**Project 25017 – HCCSC Parking & Tennis Improvements**  
Multiple Schools, Huntington County Indiana

**ADDENDUM No. 1**  
March, 6, 2025

DRAWING CONTENTS:  
PAVING PLAN -  
NORTH PARKING LOT  
ISSUE DATE: 02.25.2025 PROJECT NO: XXXX  
DRAWING NO: C-101

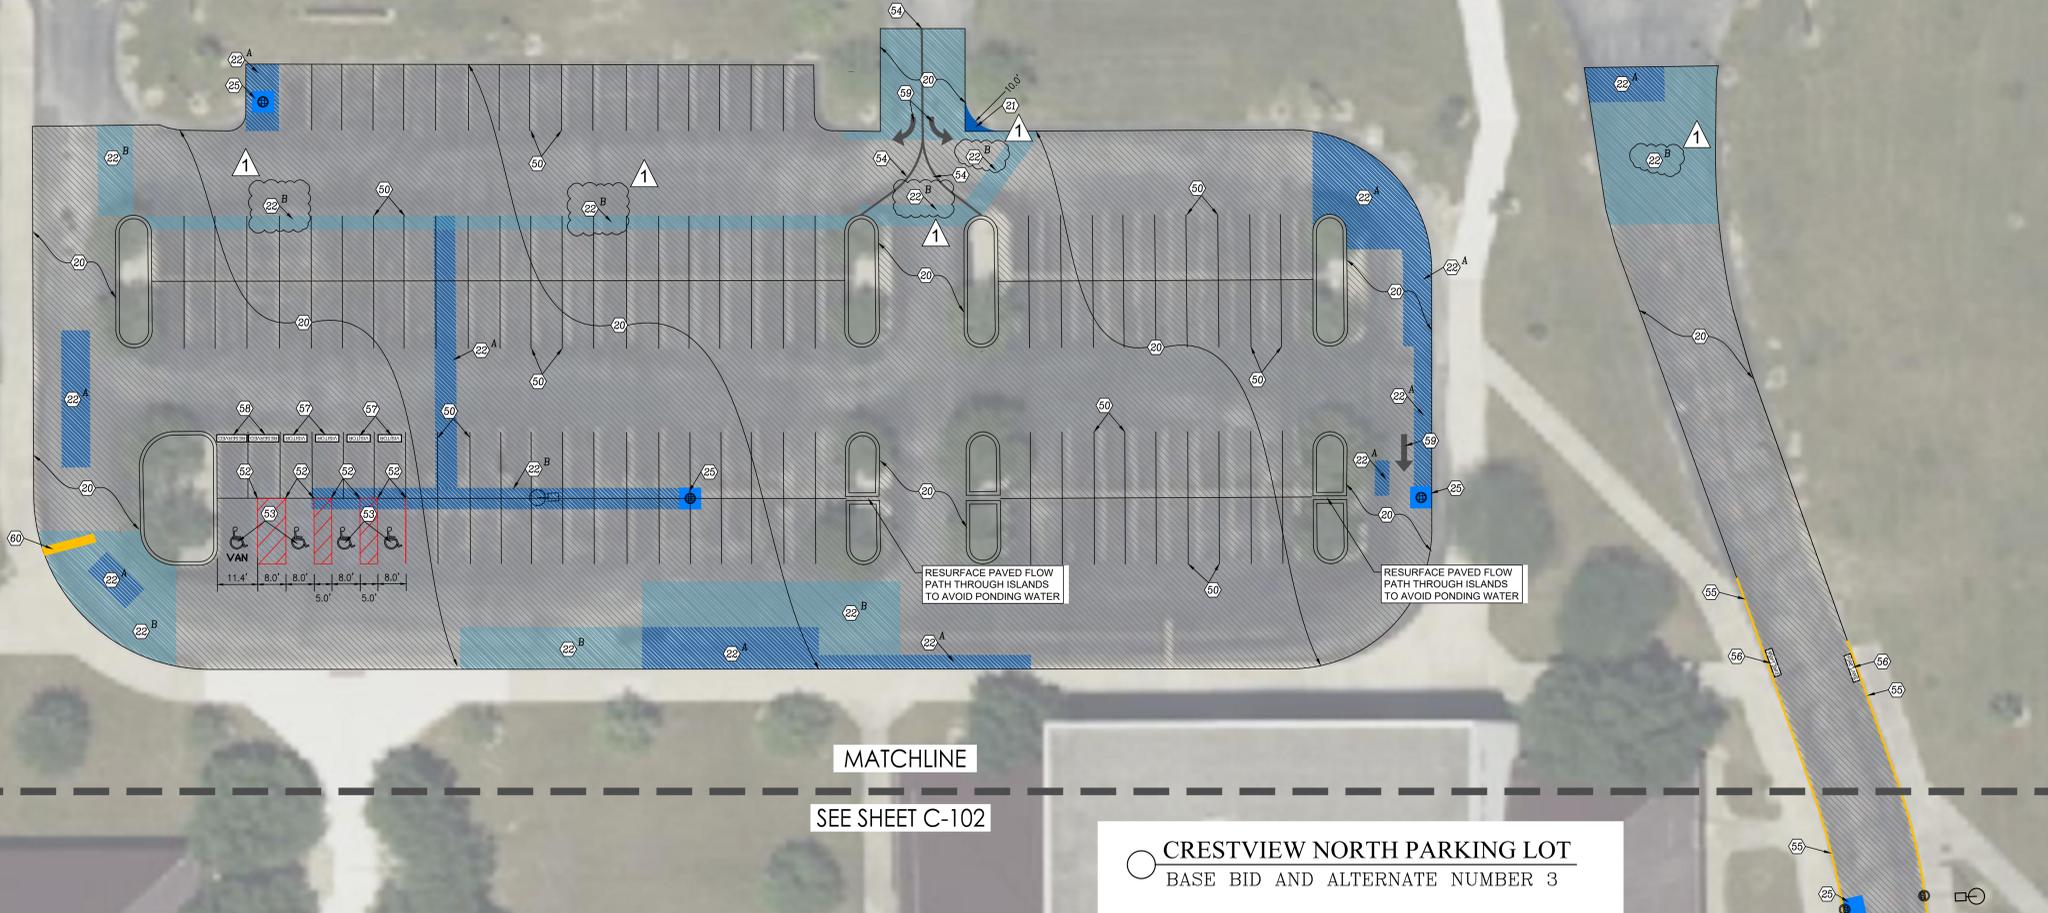
ADD. 1  
03-06-2025  
**ADDENDUM DESCRIPTION**  
C-101 CRESTVIEW  
1. NORTH PARKING - CHANGED KEYNOTE NUMBERS FROM 23B TO 22B.  
2. BUS DRIVE - CHANGED KEYNOTE FROM 22A TO 22B  
3. ADD ALTERNATE 4 - CRESTVIEW DROP OFF LANE MODIFICATIONS.

CRESTVIEW DROP OFF LANE MODIFICATIONS  
ALTERNATE NUMBER 4

ISSUE DATE: 02.25.2025 PROJECT NO: XXXX  
DRAWING NO. C-401

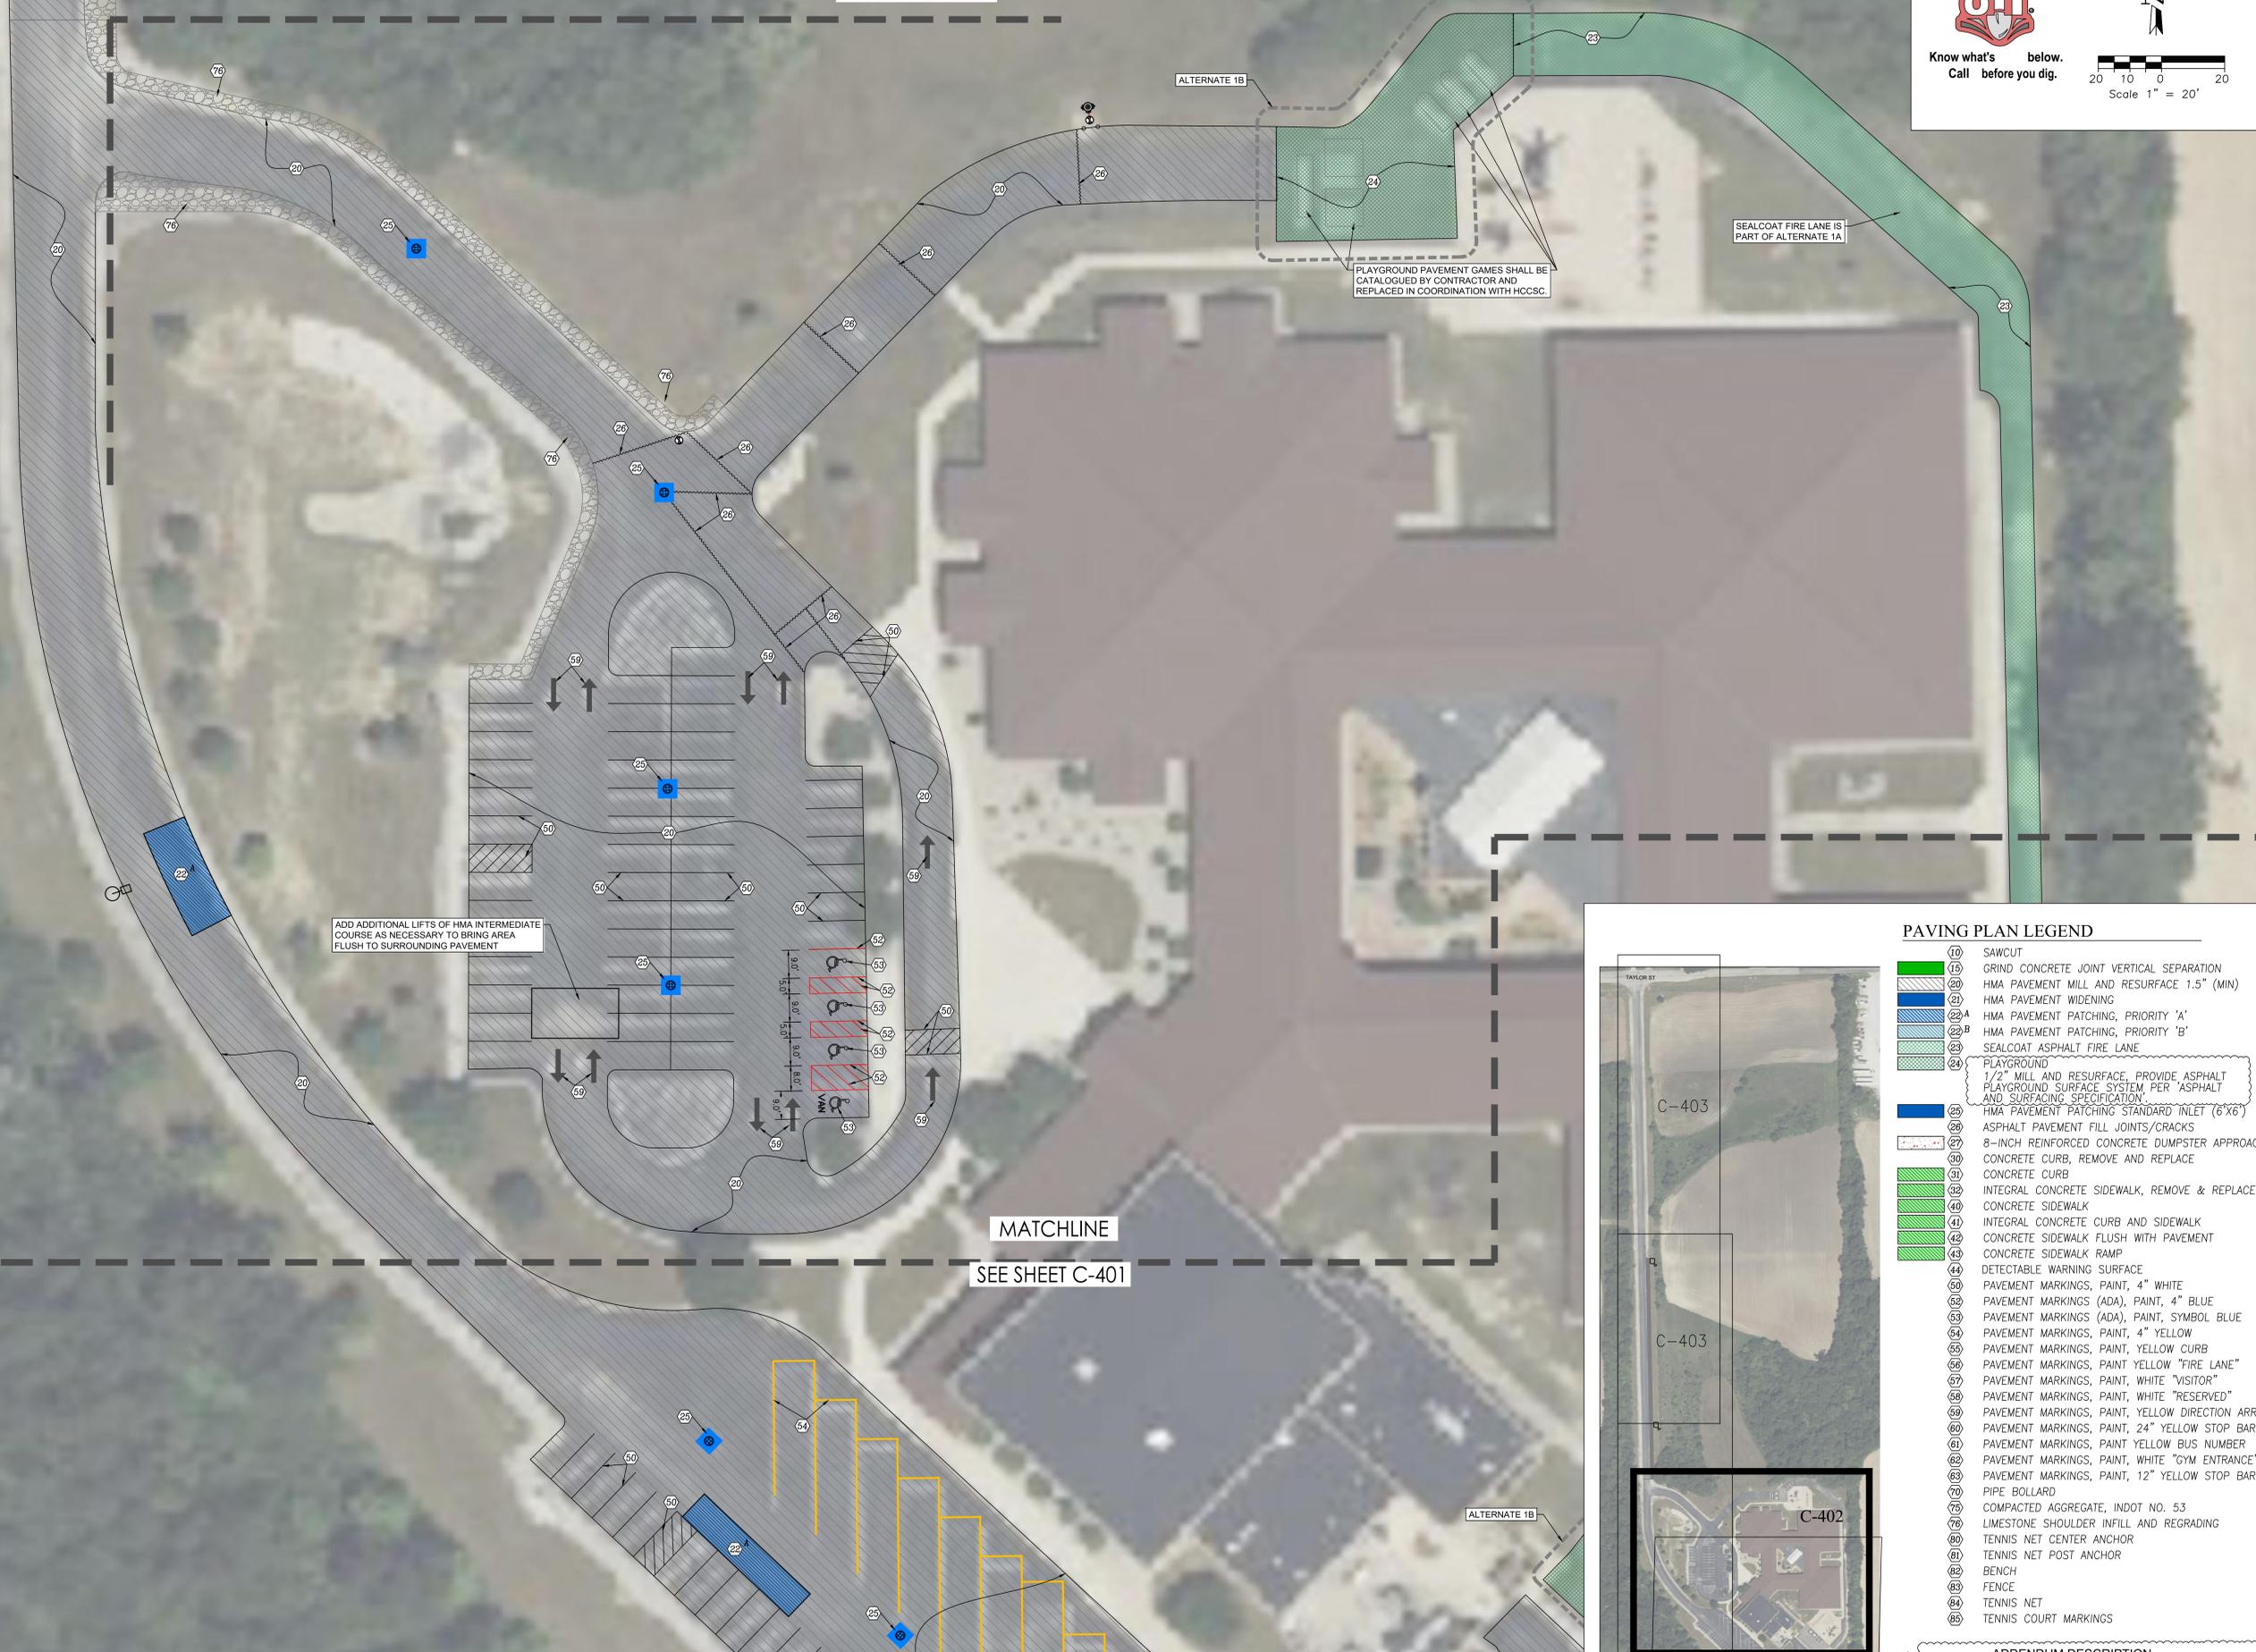
ADD. 1	03-06-2025	C-401 LINCOLN
1.		MODIFY PAVING LEGEND ITEM 24 DESCRIPTION

**C-402**

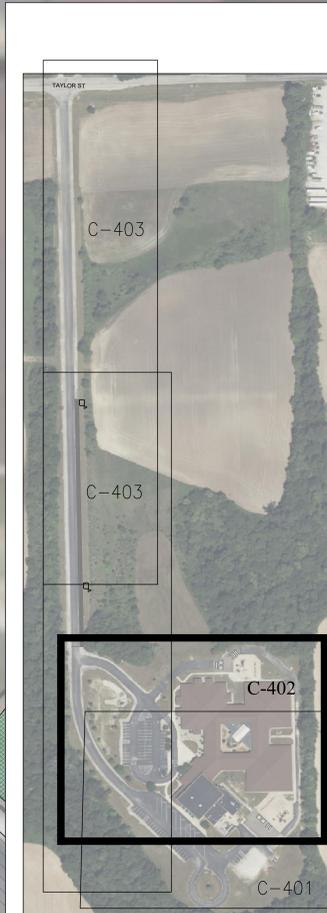
ADD. 1	03-06-2025	C-402 LINCOLN	1. MODIFY PAVING LEGEND ITEM 24 DESCRIPTION
--------	------------	---------------	---

ISSUE DATE: 02.25.2025 PROJECT NO: XXXX  
DRAWING NO: C-403

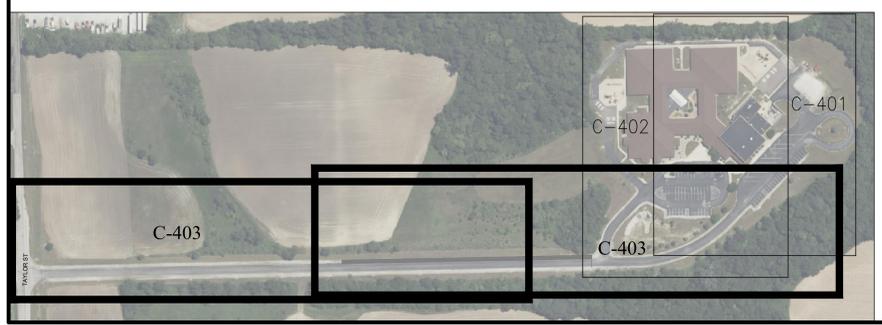
**ADDENDUM DESCRIPTION**  
ADD. 1  
03-06-2025  
C-403 LINCOLN  
1. CHANGED KEYNOTE NUMBERS FROM 26 TO 76.

20 HMA PAVEMENT PATCHING TYPICAL SECTION N.T.S.

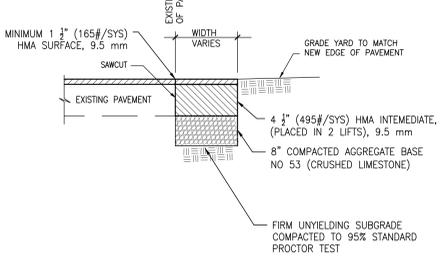
ADDENDUM DESCRIPTION
C-500 DETAILS
1. ADDED HMA PAVEMENT PATCHING STANDARD INLET (6'X6'') DETAIL
2. MODIFIED NOTES ON DETAIL 20 - HMA PAVEMENT PATCHING

NOTES:  
1. MATCH EXISTING HMA PAVEMENT DEPTH (MINIMUM 4 1/2" INTERMEDIATE/BASE)  
2. CONTRACTOR SHALL INSPECT EXISTING STONE BASE FOR SOIL INFILTRATION OR EXCESSIVE MOISTURE. IF STONE BASE IS SOFT AND DOES NOT MEET COMPACTION REQUIREMENTS, EXCAVATE STONE AND SUBGRADE TO FIRM UNWEAVING SOIL (EXCAVATION ASSUMED 4-12 INCHES BELOW ASPHALT). BACKFILL WITH COMPACTED AGGREGATE NO. 53.  
3. FOR QUANTITY ESTIMATING PURPOSES, IT IS ASSUMED THAT SOME OF HMA PAVEMENT PATCHING AREA WILL REQUIRE ADDITIONAL STONE BASE REPLACEMENT. ACTUAL EXTENT OF ADDITIONAL STONE BASE REMOVAL AND REPLACEMENT SHALL BE IDENTIFIED BY THE CONTRACTOR AND CONFIRMED ON SITE BY OWNER/ARCHITECT. PRIOR TO ANY WORK THAT WOULD REQUIRE THE USE OF THE UNIT PRICE NO. 2, AS IDENTIFIED IN THE BID FORM.
